UNITED STATES PATENT AND TRADEMARK OFFICE

Office Action Summary

10/030,799

DETAILED ACTION

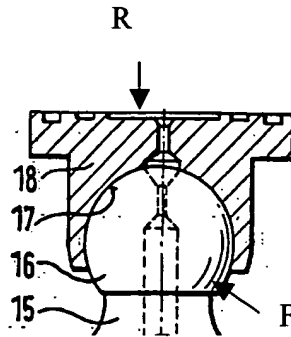
Regarding claims 20 and 23, Wagenseil discloses (Fig. 1) a ball-and-socket joint (16, 17) forming a connection between a piston 1 and a slipper 18 of a piston machine, the joint comprising a hemispherical joint recess 17 having a free recess edge, labeled as F on the Figure below, provided at one end of the piston, and a spherical joint ball 16 on the slipper being pivotably mounted in the joint recess 17. Wagenseil further discloses an outer lateral surface converging conically toward the free recess edge F, and the piston being made of hardened steel which is hardened through nitriding (col.4, l. 1-5).

Regarding claim 28, Wagenseil discloses the claimed joint including a base surface on the slipper with a recess, labeled as R on the Figure above, but fails to disclose the slipper including a base surface with a plate-shaped insert being mounted in the recess. Wiethoff teaches a plate shaped insert 132 mounted in the recess of the base member of the slipper. It would have been obvious at the time the invention was made to a person of ordinary skill in the art to include a plate shaped insert mounted in the recess of the base member of the slipper so the slipper can slide more easily.
